## **REGENCY EXECUTIVE PARK SUBDIVISION,** **UNIT TWO, RESUBDIVISION OF**

APPLICATION NUMBER 13 DATE November 18, 2004

APPLICANT Regency Executive Park Subdivision, Unit Two, Resubdivision of

REQUEST Subdivision

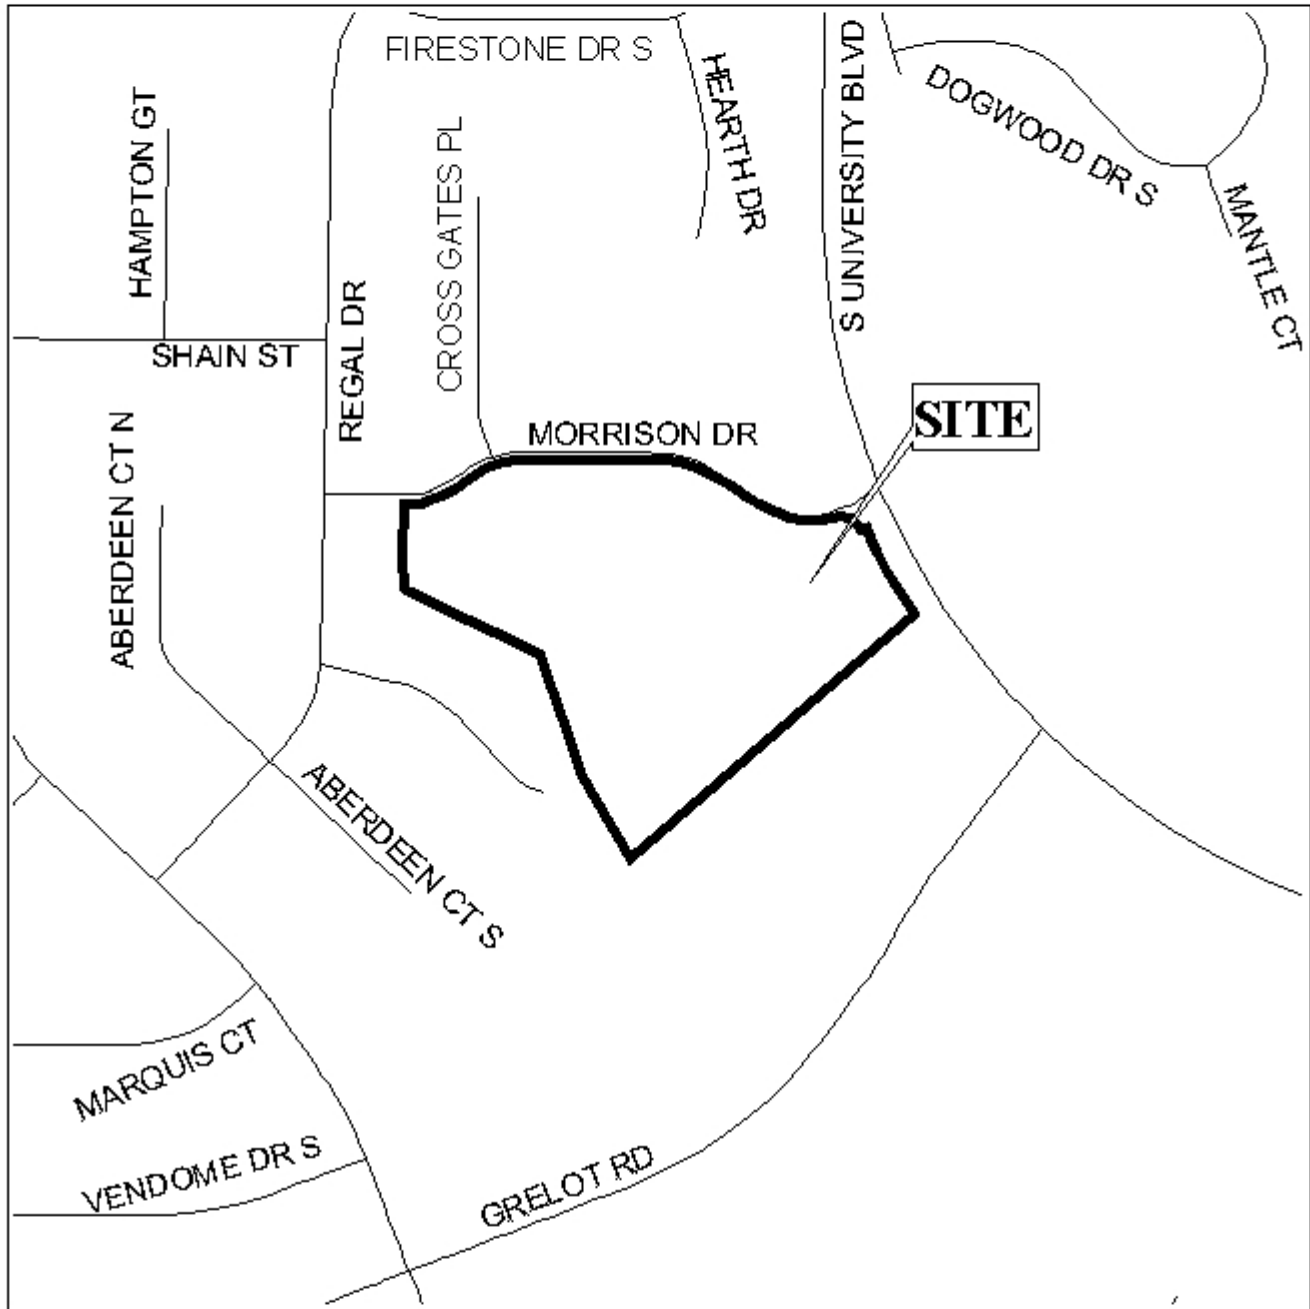
The plat illustrates the proposed 2 lot, 8.9 ± acres subdivision which is located at the Southwest corner of University Boulevard and Morrison Drive and is in City Council District 6. The subdivision is served by public water and sanitary sewer.

The site fronts University Boulevard, a planned major street, which has an existing right-of-way in compliance with the Major Street Plan. As University Boulevard is a planned major street, access management is a concern, and there is a traffic signal at the intersection of University Boulevard and Morrison Drive thus direct access to University Boulevard should be denied. Additionally, Lots 1 and 2 should be limited to one curb cut each, with the location and design to be approved by the Traffic Engineer prior to recording.

The plat meets the minimum requirements of the Subdivision Regulations and is recommended for Tentative Approval subject to the following conditions: 1) that Lots 1 and 2 be limited to one curb cut each, with the location and design to be approved by Traffic Engineering; and 2) the placement of a note on the final plat stating that the 55" Live Oak tree located on the Northeast corner of Lot 2 is to be preserved (any work on or under this tree is to be permitted and coordinated with Urban Forestry; removal to be permitted only in the case of disease or impending danger).
